Director's Corner

14 January 2010

Evolving the ILC baseline

Topological diagram of the proposed changes in the ILC central area, a much more coherent integration of this very complex central region containing the sources, damping rings, beam delivery systems, detectors, etc.

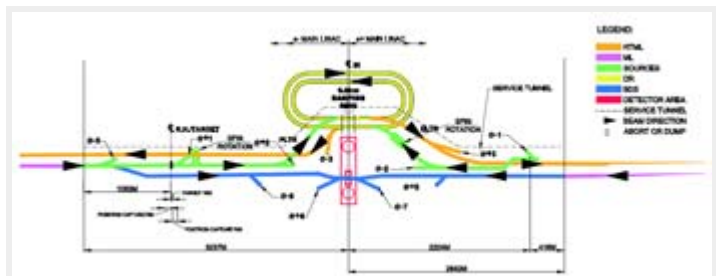
- Integration of the positron and electron sources into a common "central region beam tunnel", together with the BDS, resulting in an overall simplification of civil construction in the central region.
